MACHIAS VALLEY AIRPORT MACHIAS, MAINE MASTER PLAN UPDATE

The Machias Valley Airport Layout Plan (ALP), prepared by Jacobs/CES, and bearing your signature, is approved **subject to the following comments** and the master plan is accepted. A signed copy of the approved ALP is enclosed.

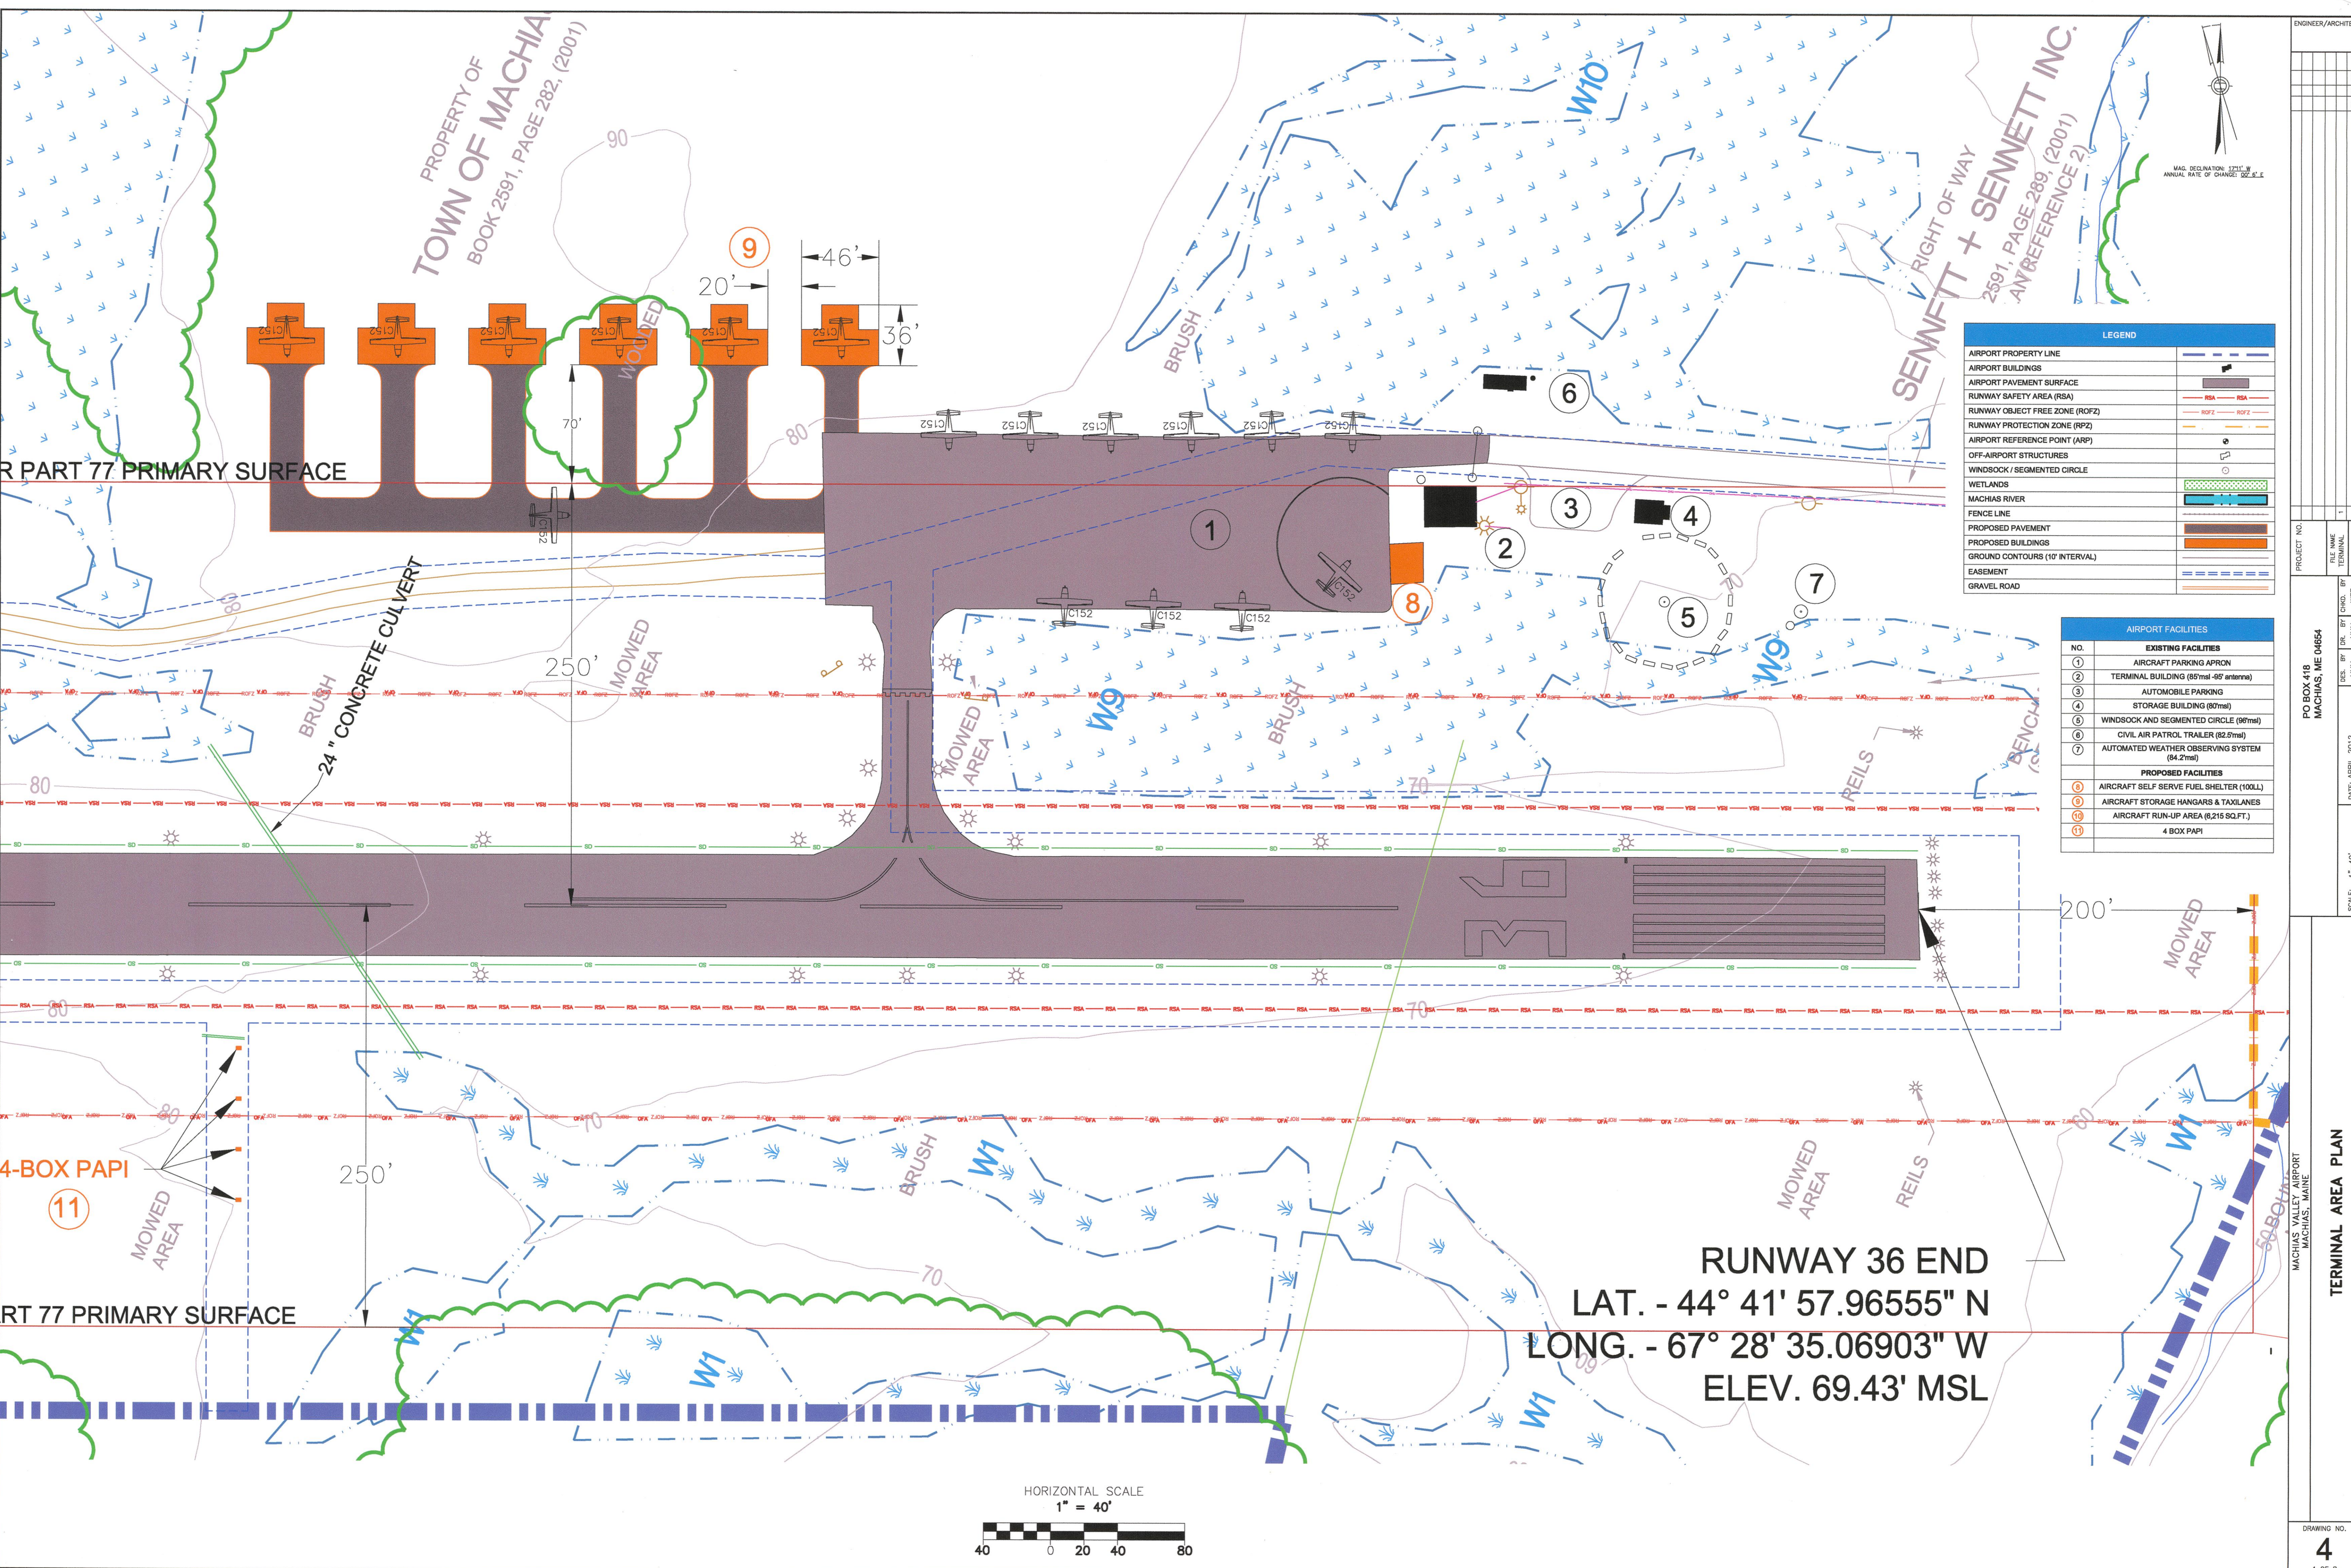
Your request for a FAA determination that it is impractical to provide standard RSA's is denied. The Runway 18 threshold should be relocated 40' to the south of its current location and the slope of the Runway 36 RSA should be brought into conformance as part of any runway reconstruction project. The proposed "hammerhead taxiway" at the Runway 18 threshold should be revised to reflect these revisions.
